PLAN COMMISSION MEETING AGENDA
Thursday, February 8, 2024 at 6:00 P.M.

CITY OF FRANKLIN
REPORT TO THE PLAN COMMISSION

REPORT TO THE PLAN COMMISSION

PEC JOB No.: 2063.00B
PEC PW: ASZ
DATE: 04/19/2022
SCALE: 1"=60'
SHEET: C-300

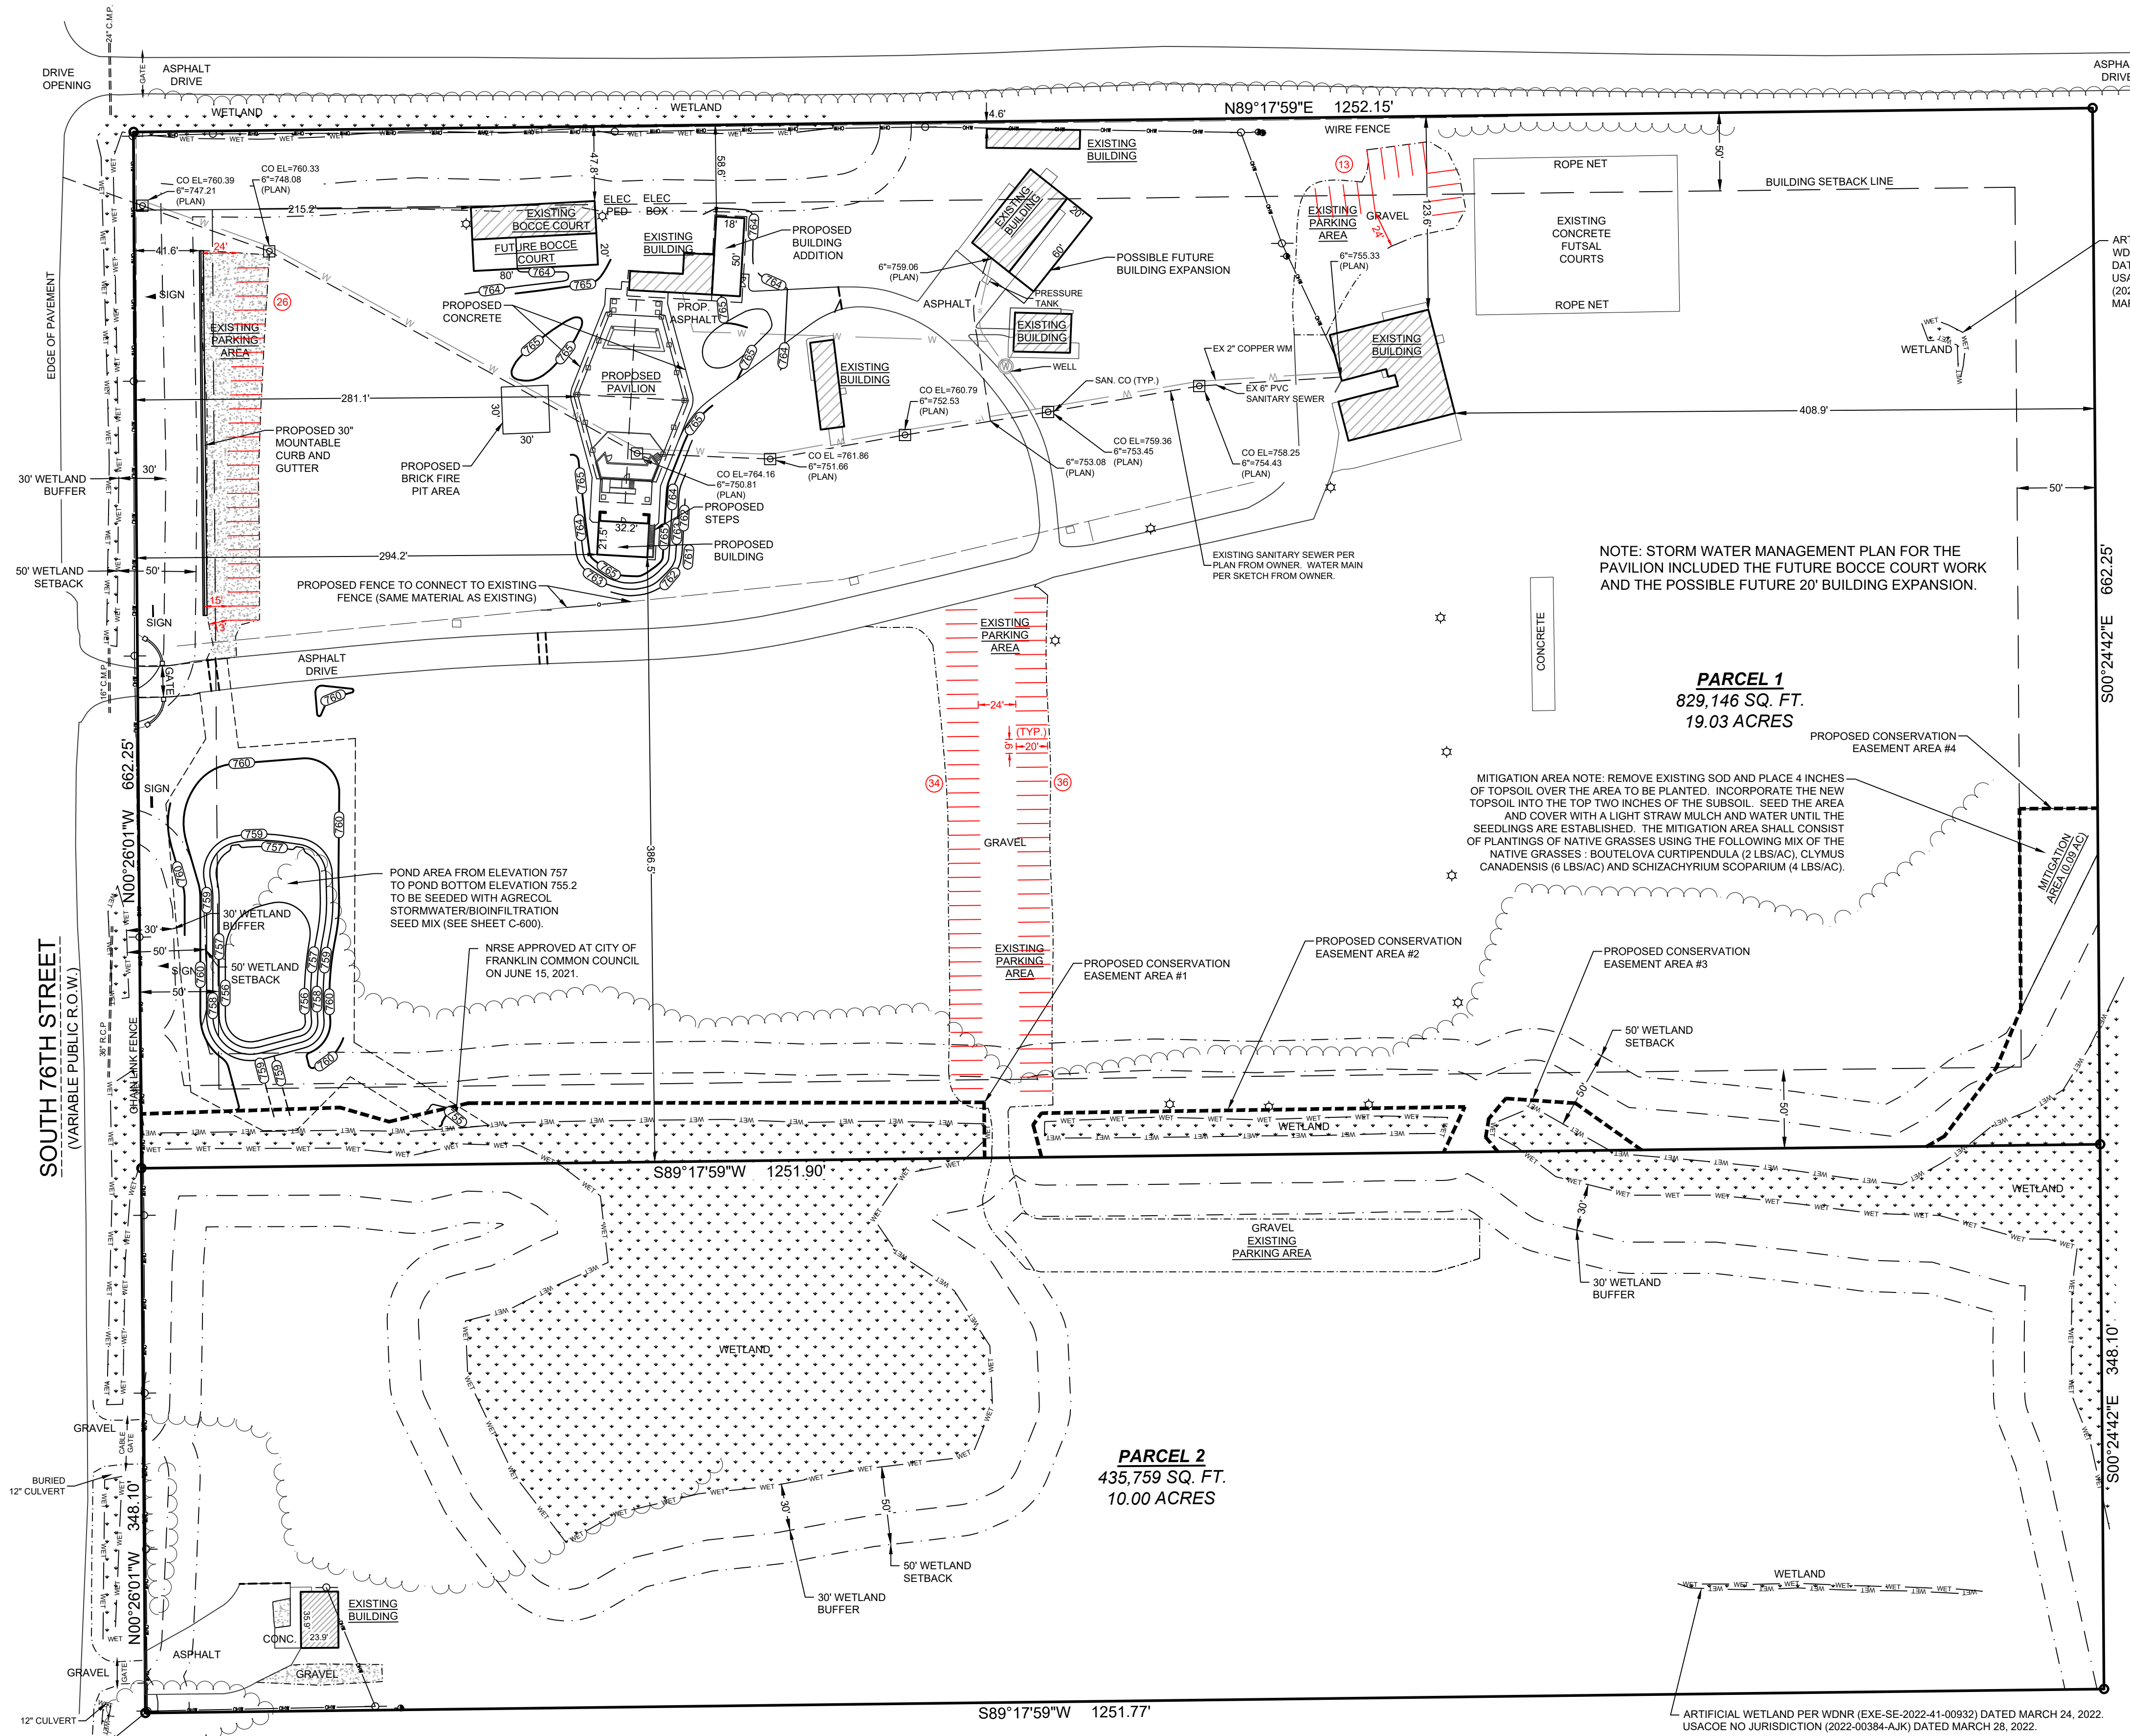
2. Please provide an updated site plan that includes information about parking for the pavilion, to confirm that adequate parking is provided. The ratio is based on occupancy of the building: 0.3 parking spaces are required per seat (Table 15-5.0203). **In the attached civil plans, see the proposed site plan sheet C-300. There are 109 spaces available on the gravel parking areas on the north property. The new Pavilion has capacity of 299. For "seated public assembly" the required parking is $299 \times 0.30/\text{person} = 90$ spaces.**

PAVILION = 299 PERSON CAPACITY
PER FRANKLIN UDO 1 SPACE PER 0.25/PERSON NOT SEATED PLACES OR 0.30/PERSON FOR SEATED FOR PUBLIC ASSEMBLY
299 X 0.25 = 75 SPACES OR 299 X 0.30 = 90 SPACES REQUIRED.
